SUBJECT: Forwards charts re steam generator tube rupture w/loss of
 offsite power & fully stuck open atmospheric dump valves.

Subject: Palo Verde Nuclear Generating Station (PVNGS)
Units 1, 2 and 3
Docket Nos. STN-50-528/529/530
Steam Generator Tube Rupture Analysis
File: 84-056-026; G.1.01.10

Reference: Letter from E. E. Van Brunt, Jr., APS,
to G. W. Knighton, NRC, dated October 5, 1984,
ANPP-30746.
Subject: Steam Generator Tube Rupture Analysis.

STEAM GENERATOR TUBE RUPTURE WITH LOSS
OF OFFSITE POWER AND A FULLY STUCK OPEN ADV
RCS LIQUID MASS vs TIME

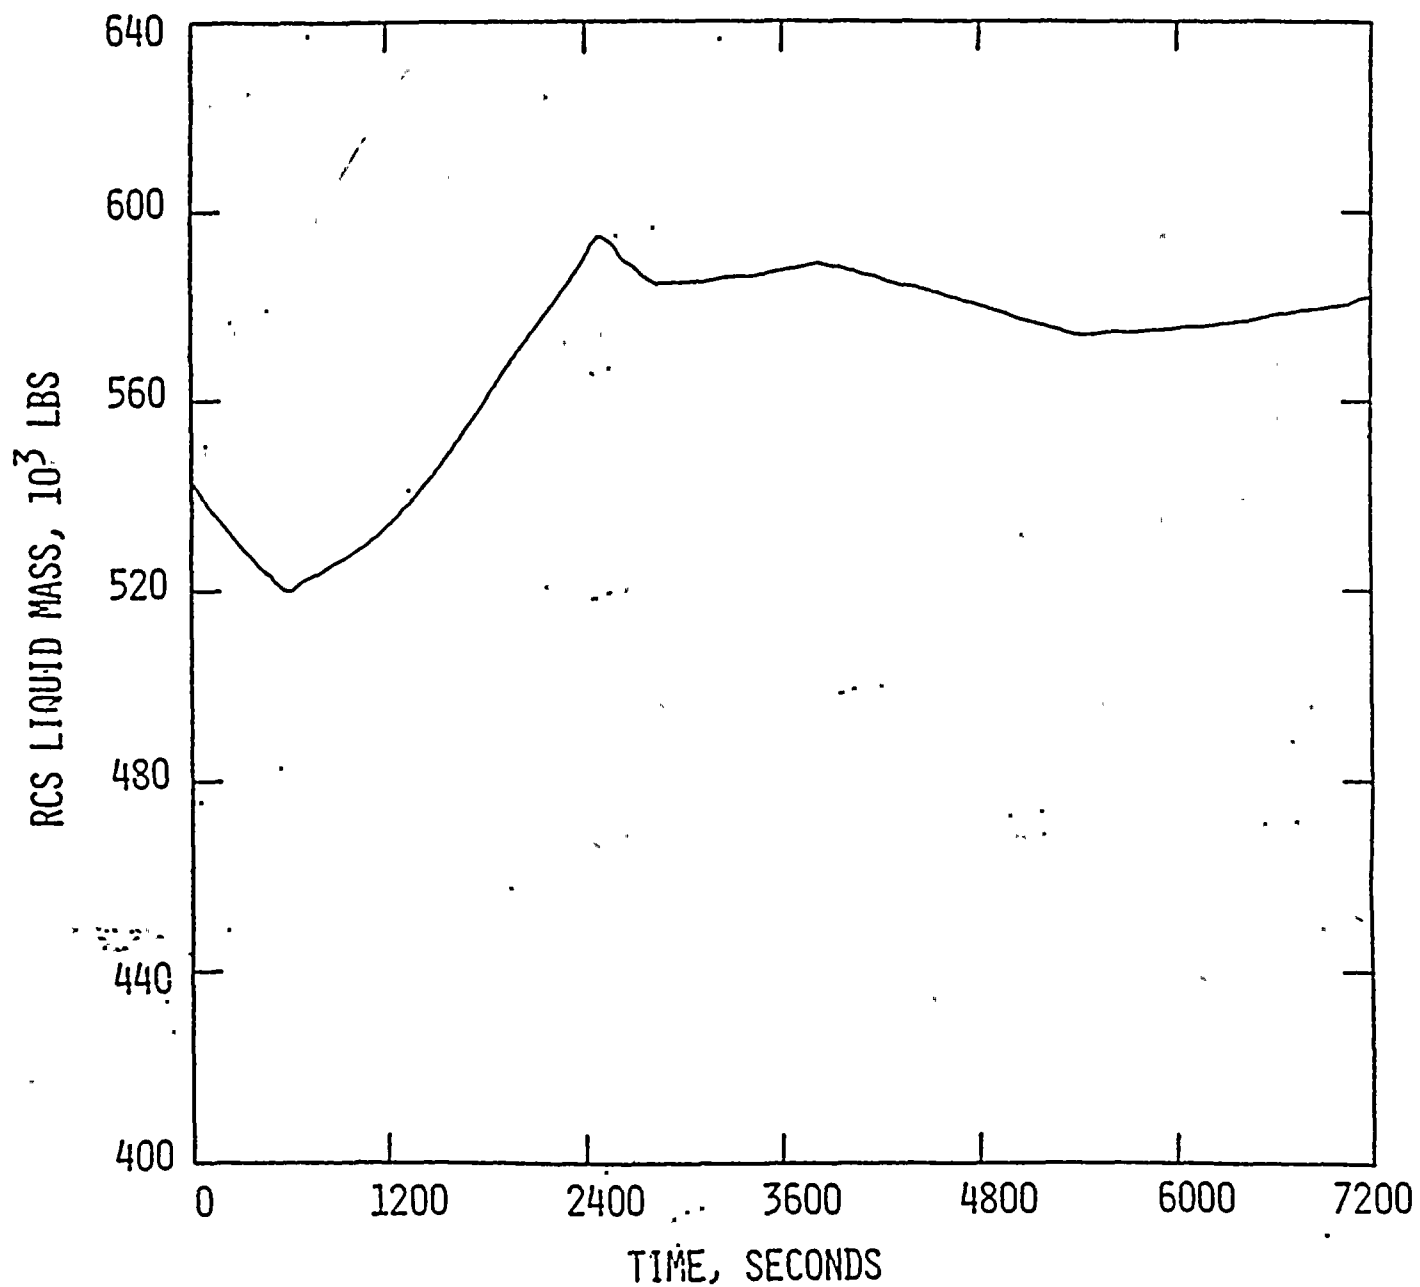
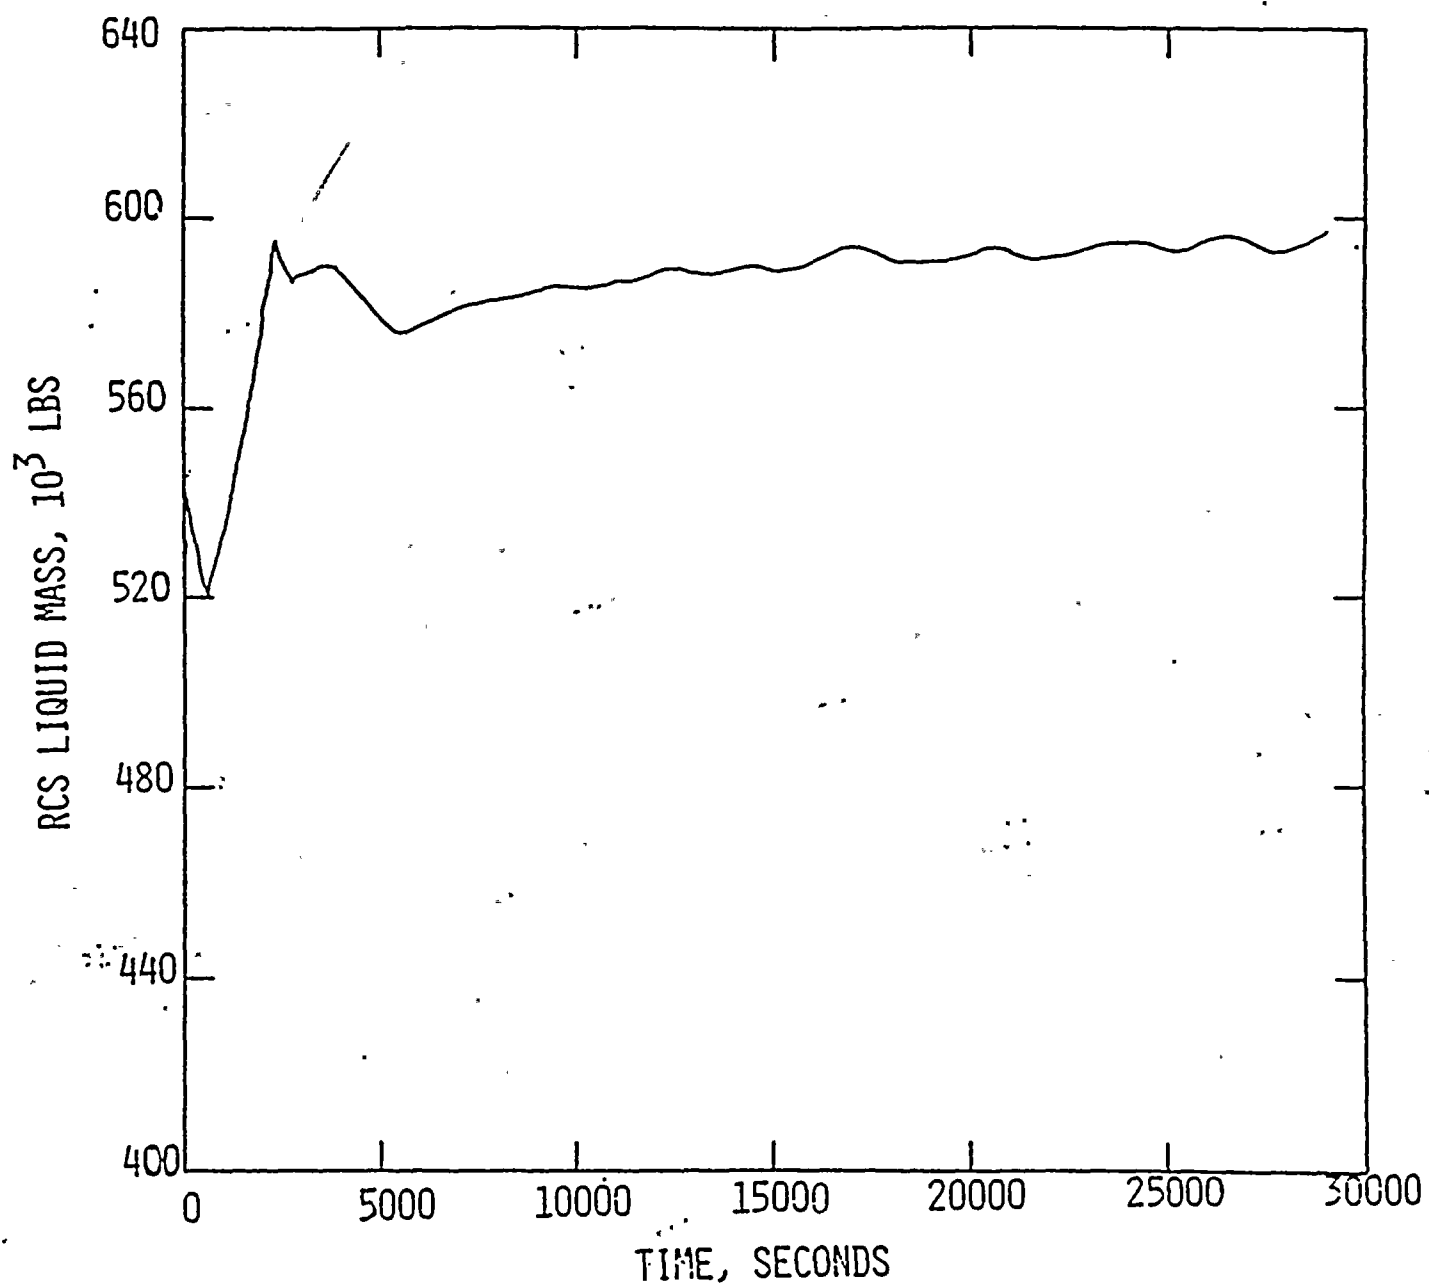
The attached curves for the steam generator tube rupture analysis supersede the corresponding curves included with the referenced letter. The attached figures show the total RCS liquid mass inventory, which includes the pressurizer and the reactor vessel upper head, as a function of time. The figures in the referenced letter showed the RCS liquid mass excluding the pressurizer and the reactor vessel upper head.
